ARKANSAS POWER & LIGHT COMPANY
POST OFFICE BOX 551 LITTLE ROCK, ARKANSAS 72203 (501) 371-4000

November 16, 1979

Subject: Arkansas Nuclear One - Unit 1
Docket No. 50-313
License No. DPR-51
Outstanding Items Related to
B&W Small Break Analysis
(File: 1510.1)

FIGURE J

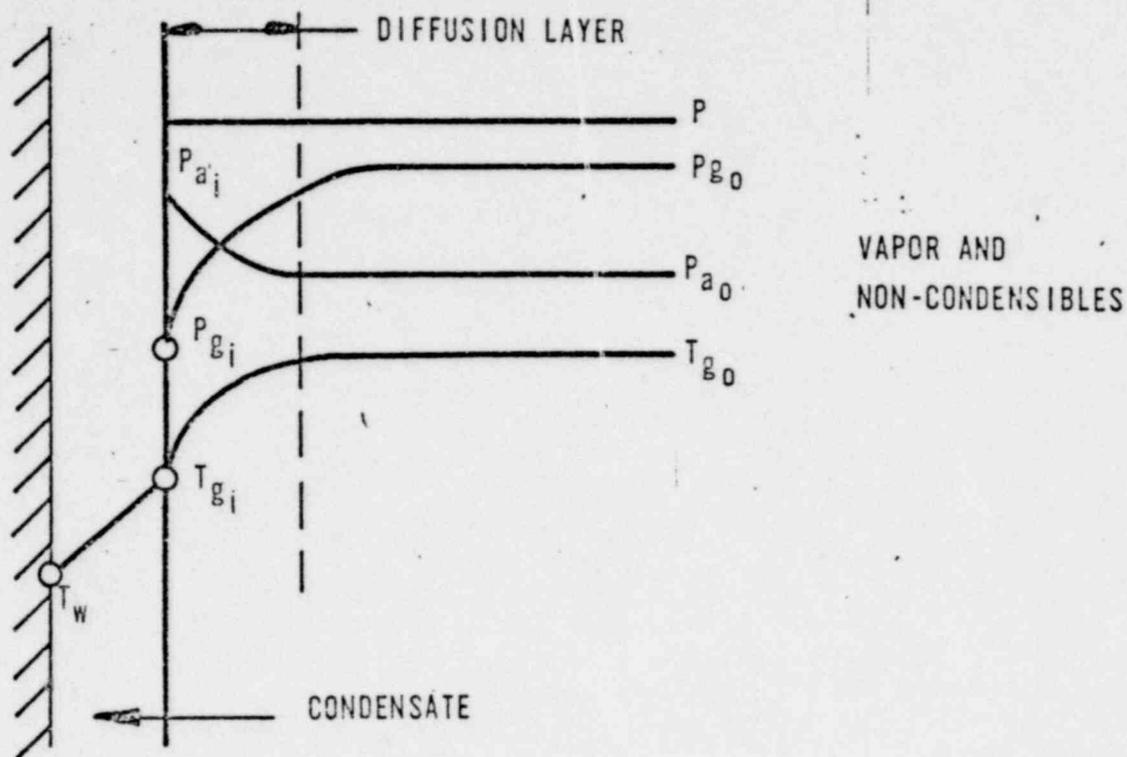
Question 3 - Noncondensable Gases

Regarding the presence of noncondensable gases within the reactor coolant system following a small break LOCA:

- A. Provide the sources of noncondensable gases in the primary system.
- B. Discuss the effect of noncondensable gases on:
 - (1) condensation heat transfer,
 - (2) system pressure calculations and
 - (3) natural circulation flow.
- C. Describe any operator actions and/or emergency procedures necessary to preclude introduction of significant quantities of noncondensable gases into the primary system.
- D. Describe operator actions to be taken in the event of a significant accumulation of noncondensable gases in the primary system.

The heat transfer during condensation is made up of the sensible heat transferred through the diffusion layer and the latent heat released due to condensation of the vapor reaching the interface (see Figure 1). The model of Colburn and Hougen⁽¹⁾ gives the following equation for the heat transfer in the vapor phase:

For the application to OTSG condensing heat transfer during small break transients, the term $hg(T_{g0} - T_{gi})$ can conservatively be neglected since the vapor velocities would be very low. Thus,

$$\phi = K_g M_g h_{fg} (P_{g0} - P_{gi}). \quad (2)$$

The heat transfer with noncondensable gases present is obtained by iteration. An interface temperature T_{gi} is assumed, which fixes P_{gi} , and the heat transfer across the liquid condensate film is computed from

The partial pressure of the gas at the bulk conditions can be calculated from the mole fraction of noncondensable gases. When the heat flux computed from equation 2 matches that computed by equation 3, the proper interface temperature has been found.
